SERVICE BULLETIN NO. 9

1999 Ford F250 - F350 SuperDuty STEERING (PITMAN ARM) INTERFERENCE

Mounting Carton 81019

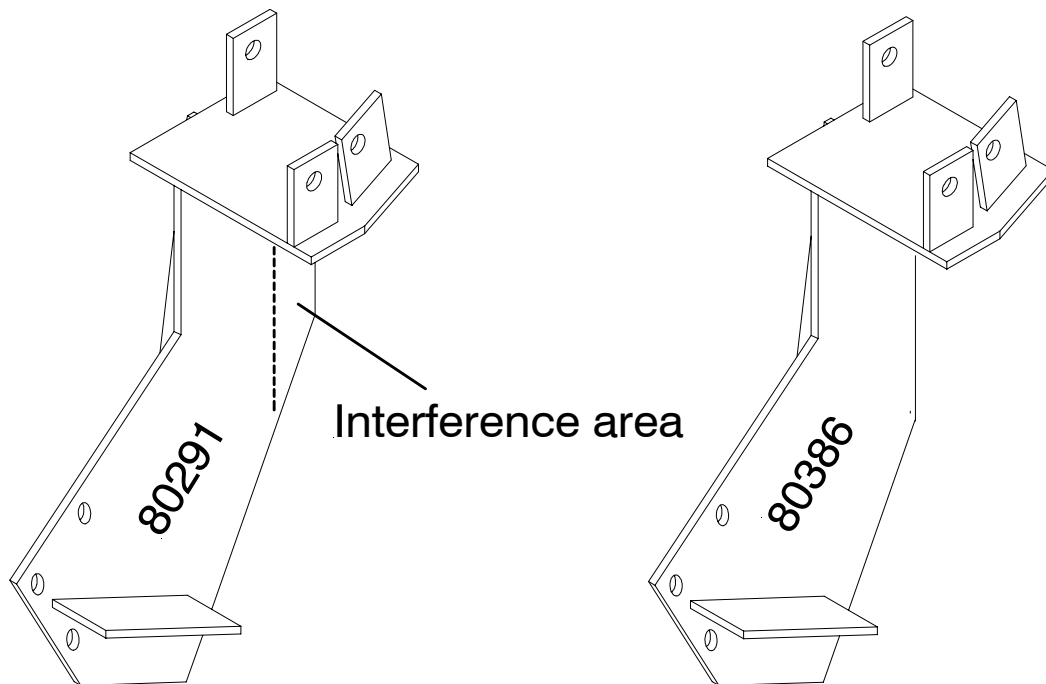
Reports from the field have indicated Interference between the steering linkage (Pitman Arm) and the Driver's side Push Arm (80291) on the Ford F250 and F350 4x4 SuperDuty vehicles.

Ford Motor Company has incorporated changes in the Steering Damper area. The steering pitman arm has been lengthened by 1.0 inch. This causes a severe interference problem when turning the steering wheel to the left. To correct the problem, Driver's side Push Arm (80291) has been re-engineered. The new Push Arm (80386) is now available. This new Push arm is only necessary on vehicles manufactured after March 15, 1999. Driver's side Push Arm (80291) will fit fine on vehicles manufactured prior to March 15, 1999.

Diamond Equipment recommends that all mountings installed on vehicles manufactured after March 15, 1999 be inspected for possible interference.
